Access Compliance Report

Public Rights-of-Way

Intersection ID: N/A	Main Street: ASCENSION_WY	Cross Street: BROOKSVALE_ST	Location: NE
ADA ID: 9CF7AA516F3D	Ramp Type: Perp	Initial Pass/Fail: Fail	Overall Compliance: No
		Severity Score: 12.5

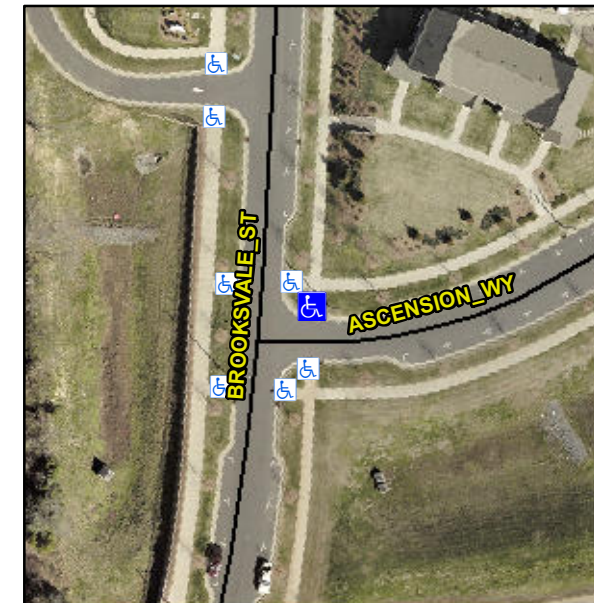
R304.2.2

Compliance	Description	Data	Compliance	Description	Data
N/A	Ramp Length (in)	68.0	No	Ramp Slope (%)	8.6
Yes	Ramp Width (in)	71.0	Yes	Ramp XSlope (%)	0.8
N/A	Flare Type LT	N/A	N/A	Flare Type RT	N/A
N/A	Flare Slope LT (%)	N/A	N/A	Flare Slope RT (%)	N/A
N/A	Flare Traversable LT?	N/A	N/A	Flare Traversable RT?	N/A
N/A	Landing Length (in)	N/A	N/A	DWS Provided?	N/A
N/A	Landing Width (in)	N/A	N/A	DWS Contrast?	N/A
N/A	Landing Slope (%)	N/A	N/A	DWS Length (in)	N/A
N/A	Landing X Slope (%)	N/A	N/A	DWS Full Width?	N/A
N/A	Landing Curb? (Y/N)	N/A	N/A	DWS Offset (in)	N/A
N/A	Shared Landing?	N/A			
N/A	Gutter Ponding?	N/A	N/A	Gutter Slope (%)	N/A
N/A	Gutter Lip Ht (in)	N/A	N/A	Gutter X Slope (%)	N/A
N/A	Painted X Walk1?	No	N/A	Painted X Walk2?	N/A
	X Walk 1 Direction	To SW		X Walk 2 Direction	N/A
N/A	X Walk 1 Width (in)	N/A	N/A	X Walk 2 Width (in)	N/A
	X Walk 1 Slope (%)	2.7		X Walk 2 Slope (%)	N/A
	X Walk 1 X Slope (%)	0.7		X Walk 2 X Slope (%)	N/A

Remove & Replace Entire Ramp.
